ATTACHMENT B

Changes to DPR-19 and DPR-25
Reactor Coolant Activity Limits and
Station Batteries LCOs

ATTACHMENT C

Proposed Change to DPR-25

Figure 3.5-1
(Sheet 2 of 5)

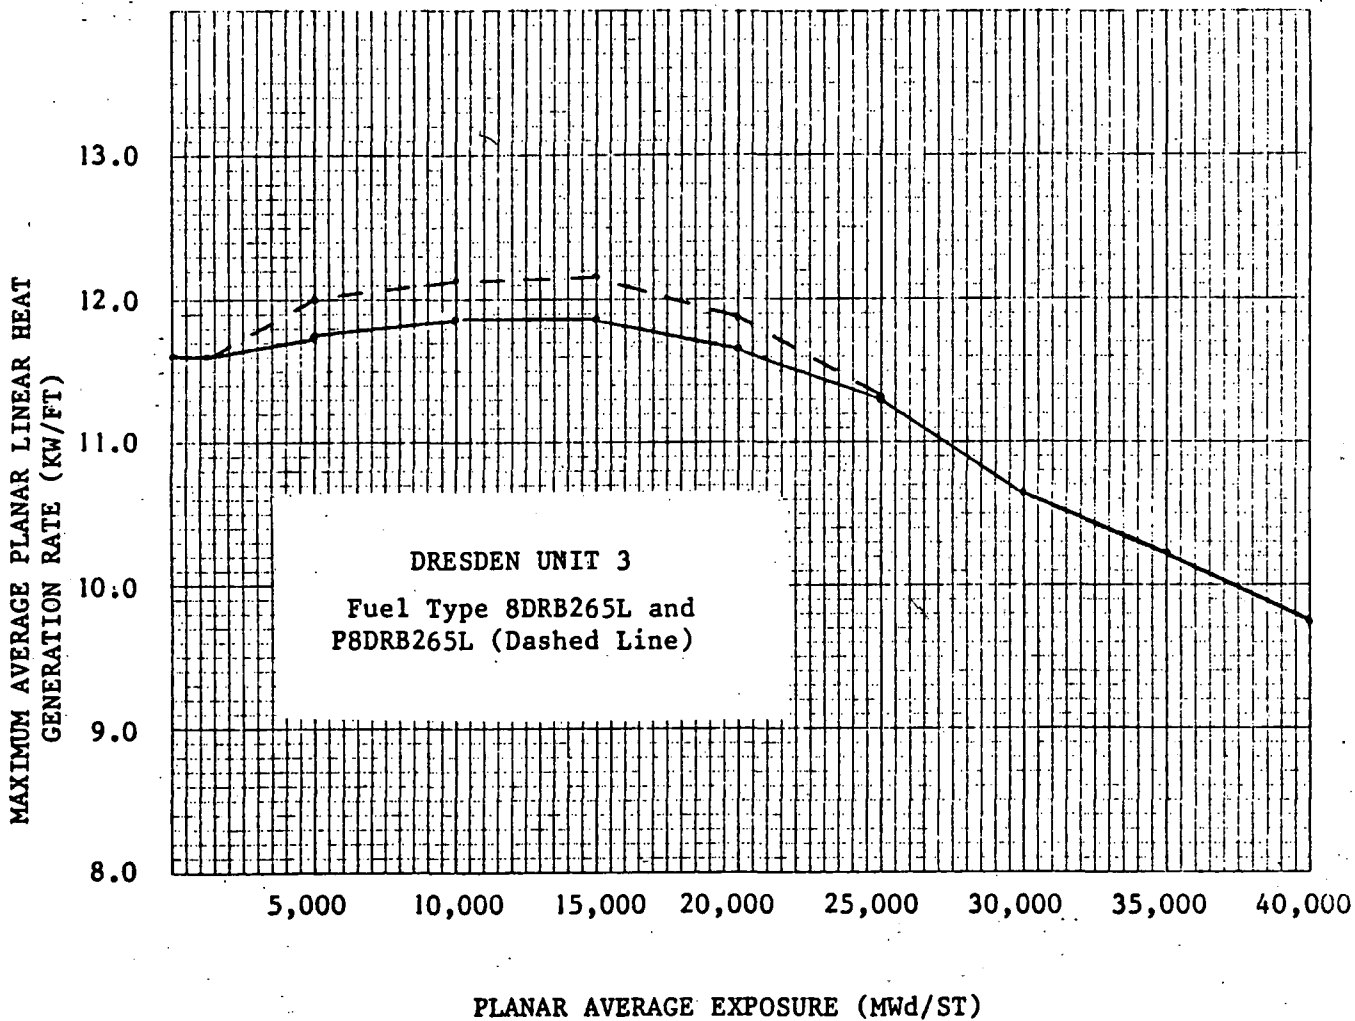
Revised page: Sheet 2 of 5 of Figure 3.5-1
